Access Compliance Report

Public Rights-of-Way (Curb Ramps)

Intersection ID: 48957	Main Street: POLLYS_GARDEN_CR	Cross Street: FRANKLIN_SQUARE_RD	Location:	N
ADA ID: 643F45DA2396	Ramp Type: Perp	Initial Pass/Fail: Fail	Overall Compliance: No	Severity Score: 8.75

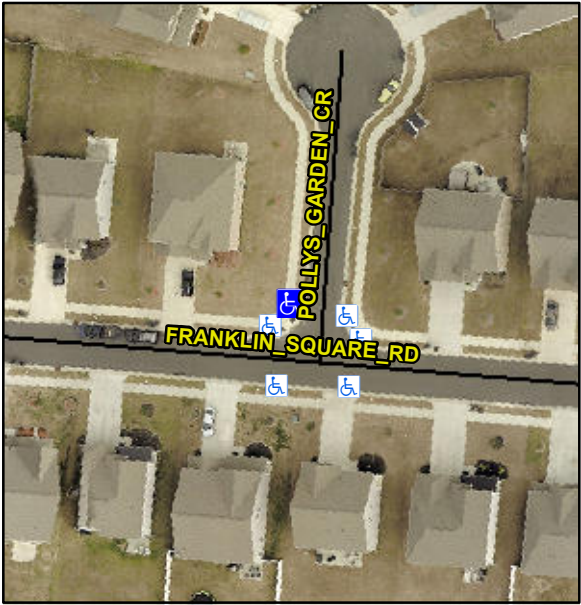
Codes/Mitigation Info/Possible Solution			Field Measurements/Component Compliance		
	Possible Solutions:		Compliance	Description	Data
	Remove & Replace Entire Ramp.		Yes	Ramp Length (in)	68.0
			No	Ramp Width (in)	47.5
			N/A	Flare Type LT	N/A
			N/A	Flare Slope LT (%)	N/A
			N/A	Flare Traversable LT?	N/A
			N/A	Landing Length (in)	N/A
			N/A	Landing Width (in)	N/A
			N/A	Landing Slope (%)	N/A
			N/A	Landing X Slope (%)	N/A
<p>Surveyor Notes:</p> <p>N/A</p>			N/A	Landing Curb? (Y/N)	N/A
			N/A	Shared Landing?	N/A
			N/A	Gutter Ponding?	N/A
			N/A	Gutter Lip Ht (in)	0.75
			N/A	Painted X Walk1?	No
			N/A	X Walk 1 Direction	To E
			N/A	X Walk 1 Width (in)	N/A
			N/A	X Walk 1 Slope (%)	1.9
			N/A	X Walk 1 X Slope (%)	1.4
			N/A	Ramp inside XWalk1?	N/A
<p>PROW/ADA:</p> <p>Not Found, R304.5.1</p>			N/A	Road Slope (%)	N/A
			N/A	Road X Slope (%)	N/A
			N/A	Any Obstructions?	N/A
			N/A	Obstruction Type	
			N/A		
			N/A
